Product Change Notification

Change Notification #: 109304 - 00
Change Title: DP45SG, PCN 109304-00, Product Design,
Component change
Date of Publication: March 29, 2009

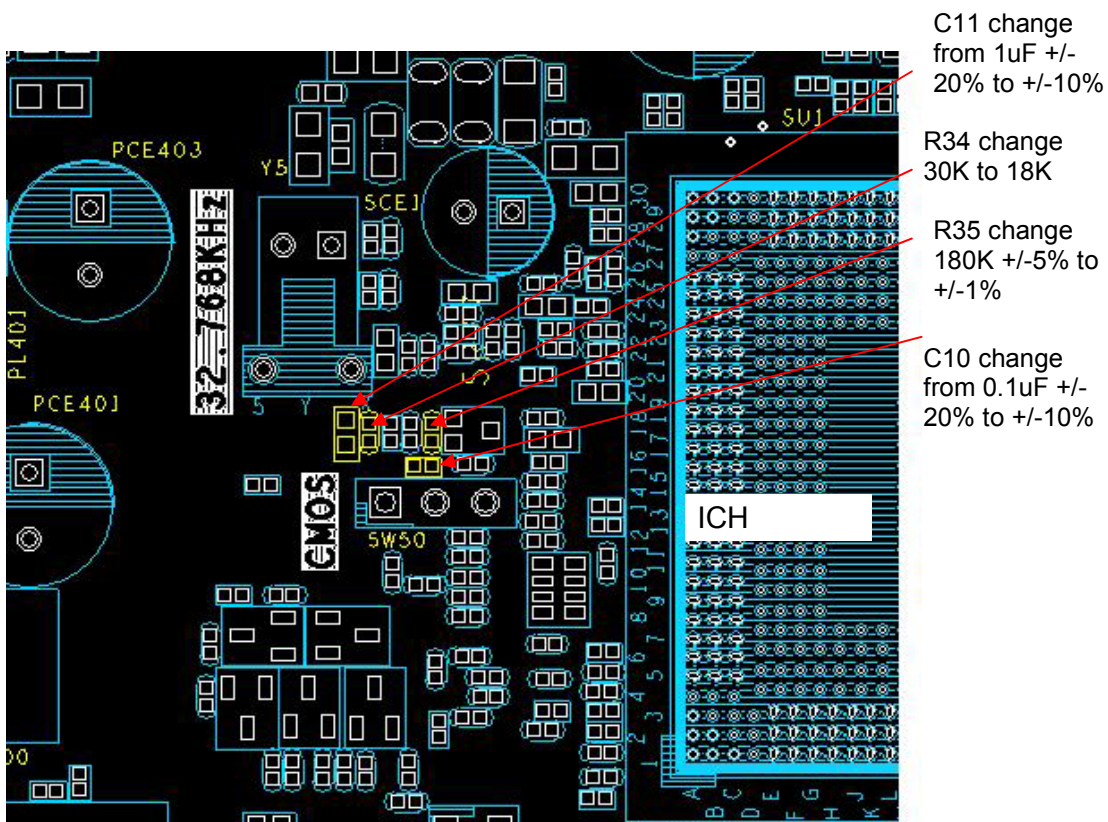
The following changes have been implemented to enhance board design and Real-time clock margins:

1. Resistor at location R34 has been changed from 30k Ohm to 18k Ohm
2. Resistor at location R35 has been changed from 180k Ohm +/-5% to +/-1%
3. Capacitor at location C10 has been changed from 0.1uF +/-20% to +/-10%
4. Capacitor at location C11 has been changed from 1uF +/-20% to +/-10%
